Subject: Application for Revision 9 to Certificate of Compliance No. 9302, Response to Second Request for Additional Information, Docket No. 71-9302 and EPID-L-2018-LLA-0000

Enclosure 1 to E-52844

RAI Responses

Figure 2-2.1—RWC-W and RWC-B

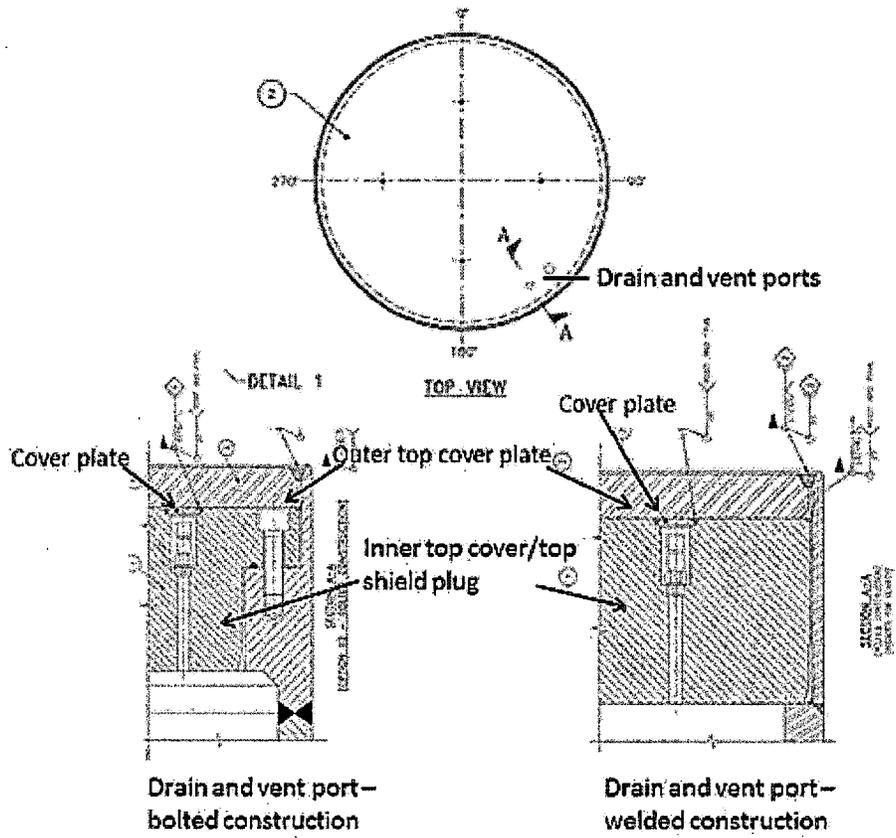
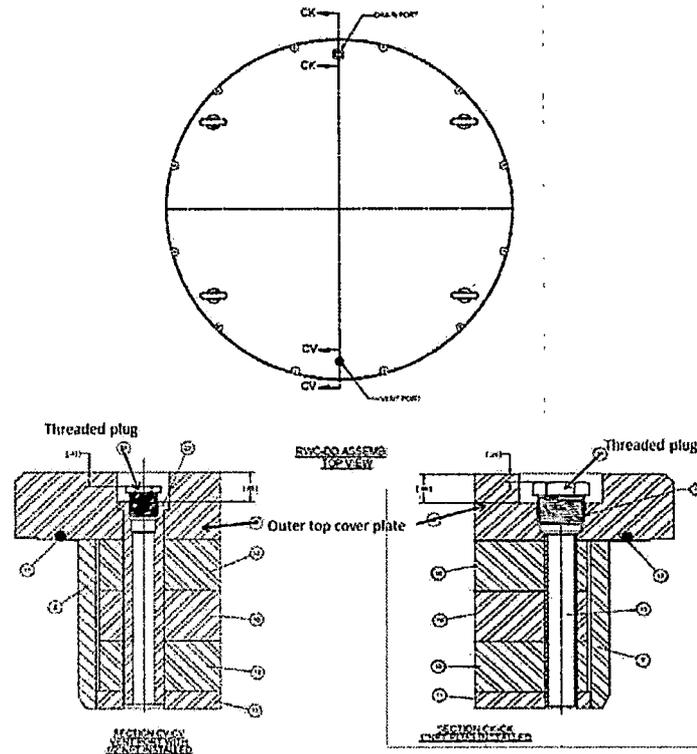
Justify the recategorization of the siphon and vent port cover plate from Quality Category A (per Drawing No NUHRWC-71-1001, Revision 1) to not-important-to-safety (NITS) (per Drawing No NUHRWC-71-1001, Revision 3). Justify the removal of all quality assurance requirements for the RWC's grapple ring and grapple ring support: such subcomponents were revised from Quality Category C (per Drawing No NUHRWC-71-1001, Revision 1) to NITS (per Drawing No NUHRWC-71-1001, Revision 3).

The applicant states that "The level of detail provided in the previously approved drawings (12 sheets) for features of the RWC that are not important to safety is not required for the technical evaluations, and many of the features of the design are common to the RWC-W, RWC-B, and RWC-DD. Furthermore, the RWC internals described in the previously-approved Drawing NUHRWC-71-1002, Revision 1 are not needed for the purpose of the safety analysis, and the bolted closure design described in the previously-approved Drawing NUHRWC-71-1003, Revision 0 has been brought into Drawing NUHRWC-71-1001." However, the applicant did not provide a justification for the recategorization of the siphon and vent port cover plate from Quality Category A to not-important-to-safety (NITS) nor did it justify the downgrading of the RWC's grapple ring and grapple ring support from Quality Category C to NITS.

None of these design features (siphon and vent port cover plate, or grapple ring and grapple ring support) for configuration options RWC-W, RWC-B, and RWC-DD as described in the MP197HB, is considered important for the structural, thermal, containment, or shielding performance of the package design. Therefore, no leak-tightness criterion is required for the RWC for transportation (see SAR Appendix A.7.7.10).

Two different port closure designs are used to seal these penetrations: One design for the RWC-W and RWC-B uses a small, approximately quarter-inch thick circular cover plate (typically called 'siphon and vent ports cover plate') welded over these penetrations, and the other design for the RWC-DD uses a small threaded plug that is screwed into the penetrations. The two port closure configurations are shown in Figures 2-2.1 and 2-2.2 below.

The discussion below applies to either port closure design, regardless of whether the design is a welded cover plate or threaded plug.

There is no leak-tightness criterion for containment that is required of the RWC for transportation (see SAR Appendix A.7.7.10). The drain and vent ports are also too small to have a significant effect on shielding effectiveness for the RWC radioactive contents. However, these closures may function to keep small debris inside the RWC as assumed for the shielding analysis. The RWC-W and RWC-B designs both have an outer top cover plate that is seal-welded prior to shipment, whereas the outer top cover plate is integral to the closure lid for the RWC-DD design, and the vent and drain ports penetrate the outer top cover plate. The function of retaining any contents debris within the RWC shell is provided by the threaded plug for the RWC-DD and by both the welded cover plate, and welded outer top cover plate for the RWC-B and RWC-B. Quality Category B is appropriate for the cover plate and threaded plug as both can be considered safety features that keep contents debris inside the RWC where shielding is provided by the RWC.

Drawing NUHRWC-71-1001 was also revised as described in the response to include details of the vent and drain ports with a quality classification as Quality Category B for the threaded plug and cover plate.
